ARMED FORCES RADIOBIOLOGY RESEARCH  
INSTITUTE (AFRRI)  
RESEARCH REACTOR  
LICENSE NO. R-84  
DOCKET NO. 50-170

TECHNICAL RAI RESPONSES (DATED 10/20/2011)

SUBJECT: REQUEST FOR ADDITIONAL INFORMATION REGARDING THE  
APPLICATION FOR LICENSE RENEWAL (TAC NO. ME1587)

## ANSWERS TO TS-RELATED QUESTIONS QUESTIONS 14-41

Figure 7-1 AFRRRI Power Instrument Ranges

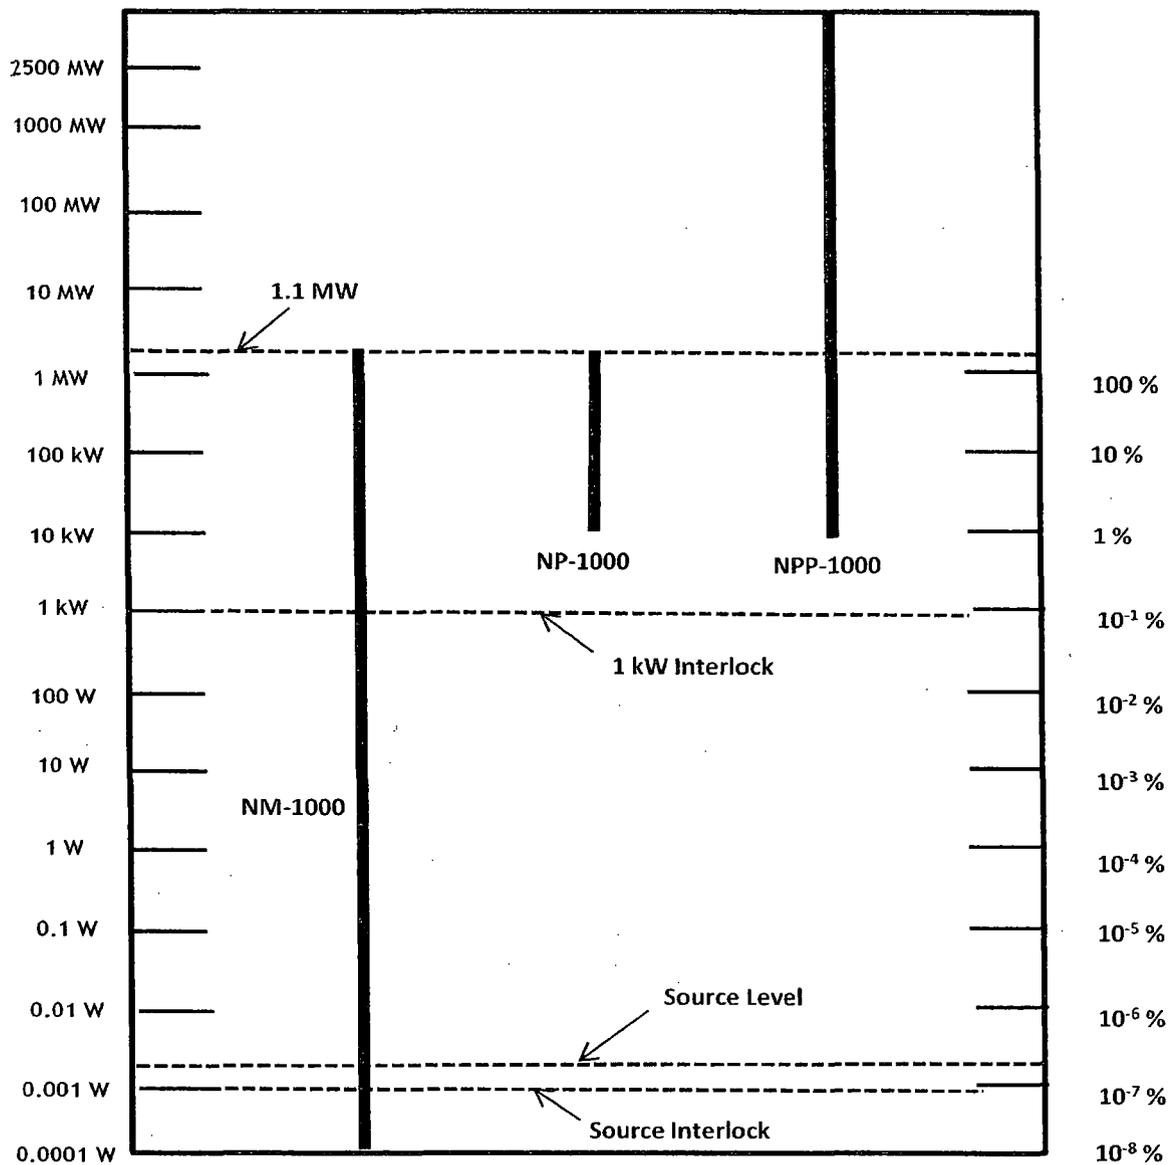
20. *TS 3.2.1, Table 1: ANSI/ANS-15.1-2007, Section 3.2 provides guidance for the reactor control and safety systems. In Table 1 in TS 3.2.1 identifies a Pulse Energy Integrating Channel. This instrument is not described in the SAR. Please clarify.*

The channel name in Table 1 is changed to “Power Pulsing Channel.” This is the name used in the revised SAR Chapter 7 that will be submitted as part of the overall relicensing application. The four relevant pages of Chapter 7 are included as Attachment 1.
